RE: 4219 San Isidro St NW
Conceptual Grading and Drainage Plan
Engineer's Stamp Date: 10/29/2025
Hydrology File: F13D040

CONCEPTUAL GRADING AND DRAINAGE PLAN

Tracts 173-B-1 and 173-C-1
 M.R.G.C.D. Map No. 31
 Being Comprised of
 Tracts 173-B and 173-C
 M.R.G.C.D. Map No. 31
 City of Albuquerque
 Bernalillo County, New Mexico
 October 2025

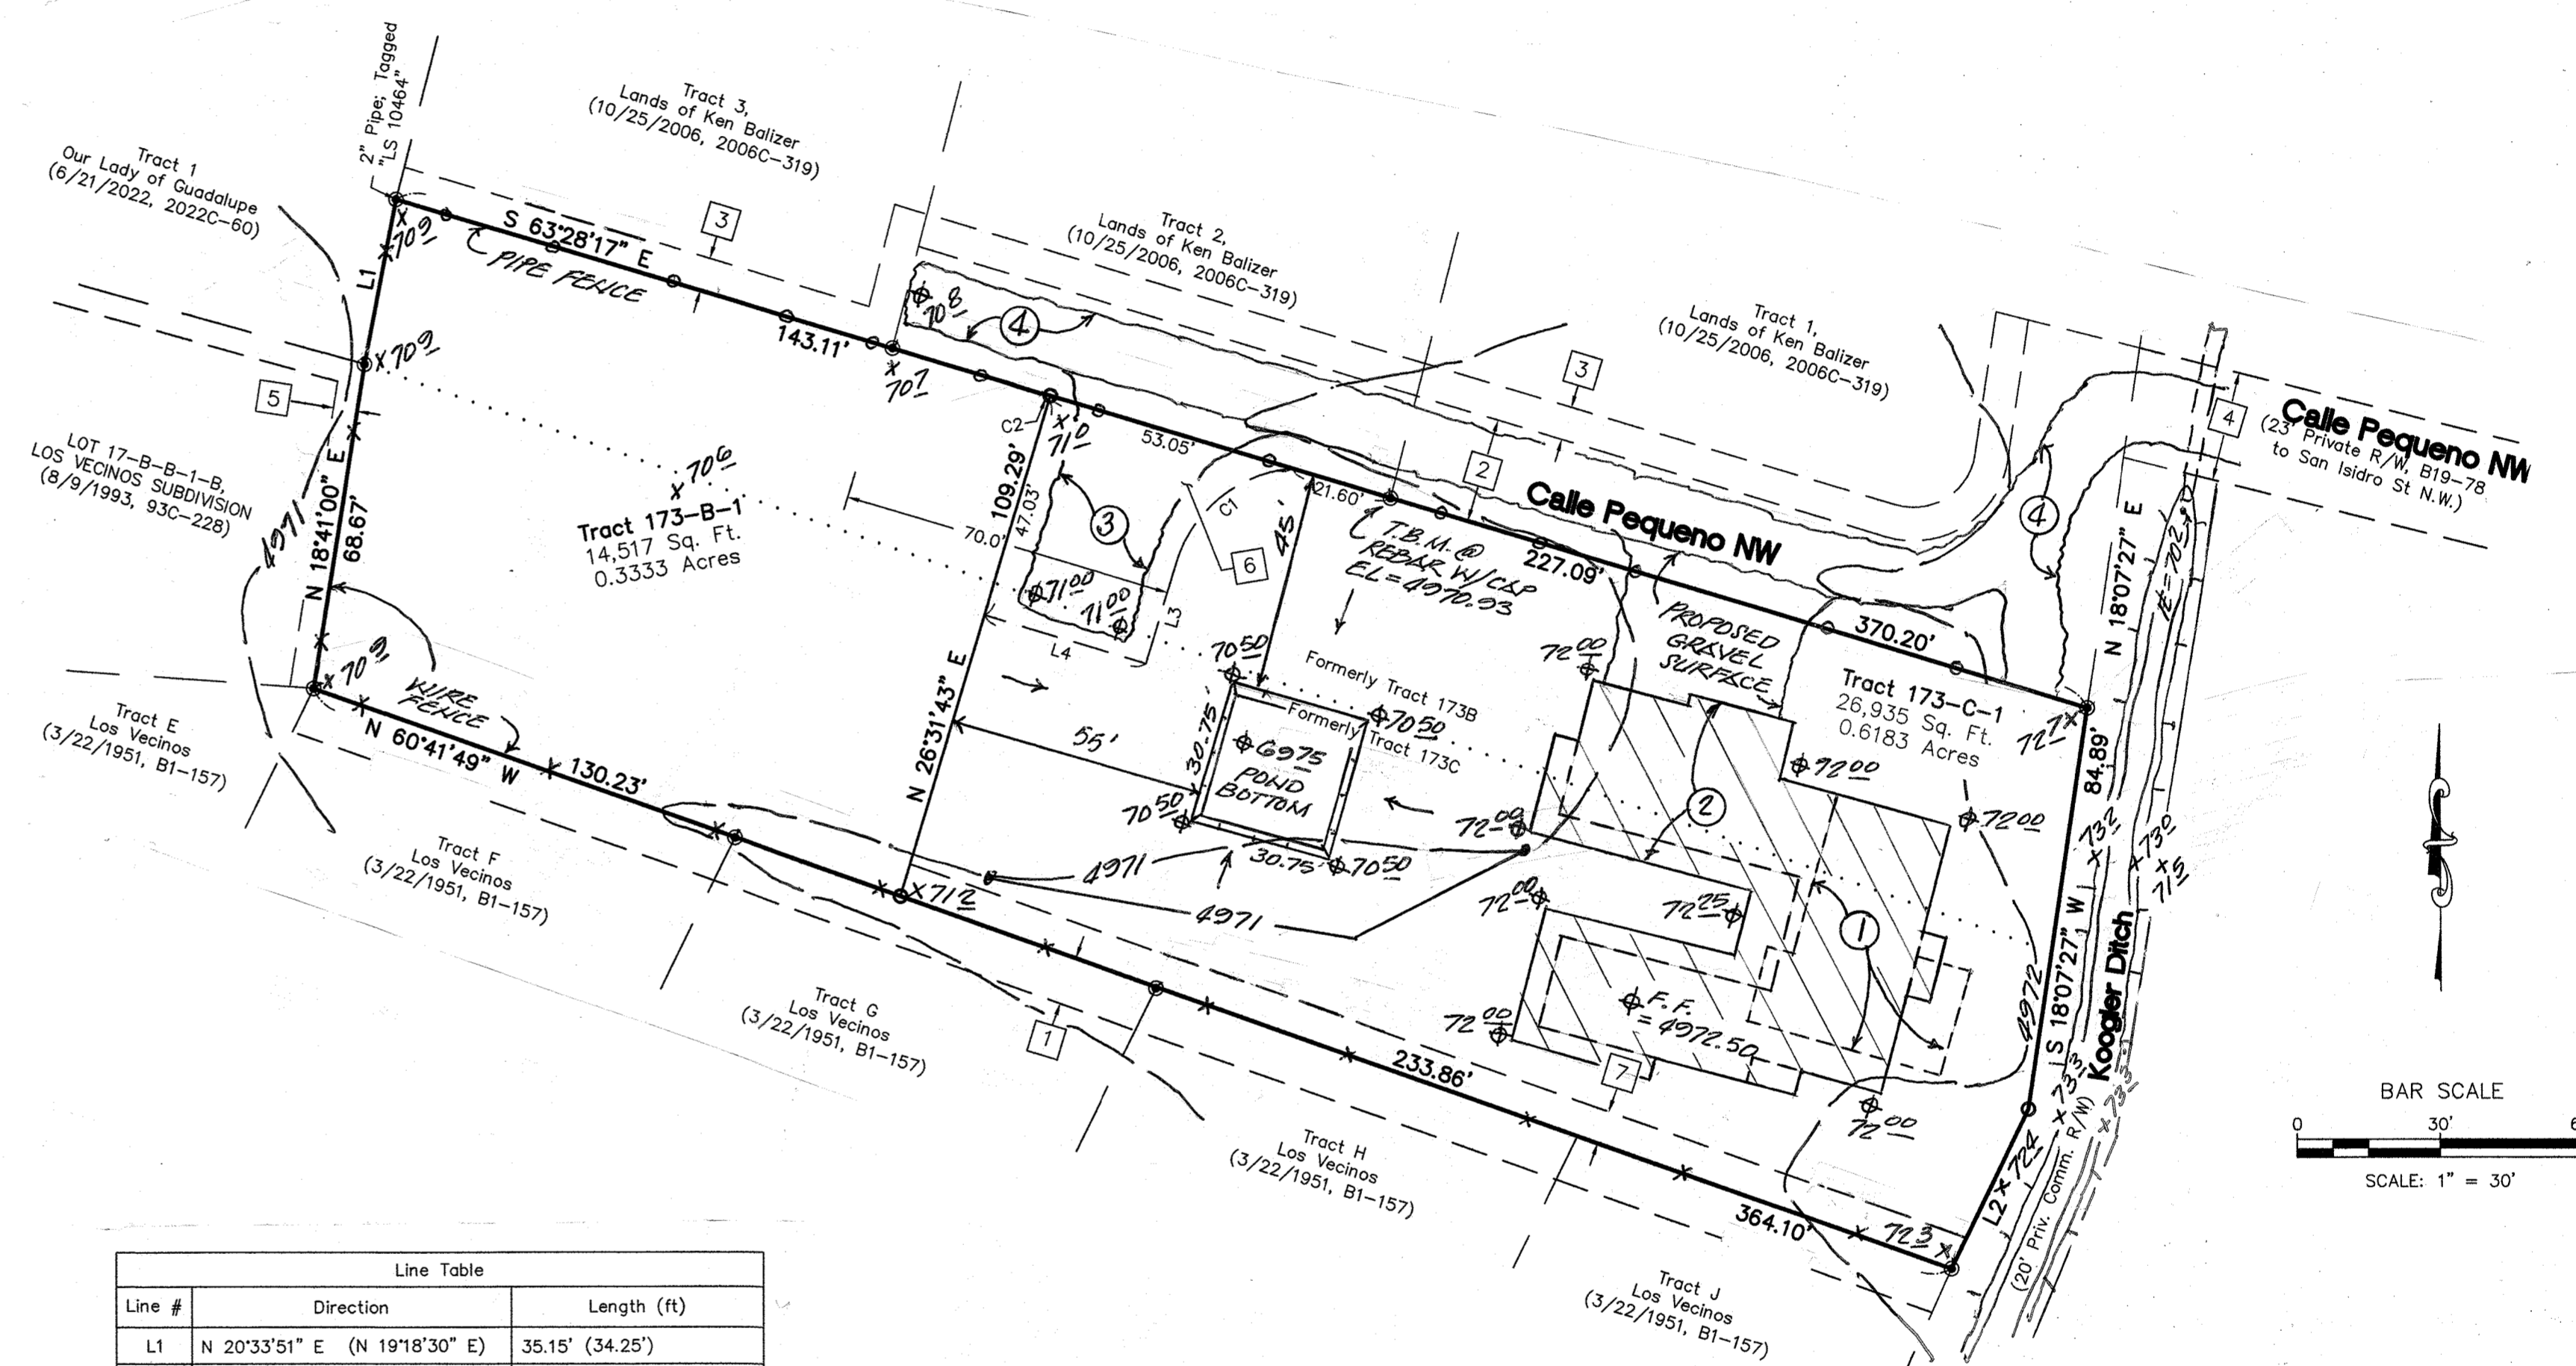
1. Please show Cross Lot Drainage Easements on both the Plat and the Grading & Drainage Plan specifying the beneficiary and maintenance agreement.
2. Per the DPM Article 6-5, the Valley Drainage Criteria will apply.
 - a. Per Part 6-5(A) #3: The Finished Pad elevation is recommended to be a minimum of 18 inches above the edge of pavement or roadway.
 - b. Per Part 6-5 (B): Show the calculation for the retention pond to retain the 100-yr 10-day storm. Verify that this volume is adequate for the proposed pond.
 - c. Per Part 6-5(D) #4: The Finished Pad elevation shall be a minimum of 1 foot above the 100-year 10-day stormwater surface elevation.
 - d. Per Part 6-5(D) #6: A permanent perimeter wall or barrier around the development is required to contain the 100-year 10-day developed runoff.
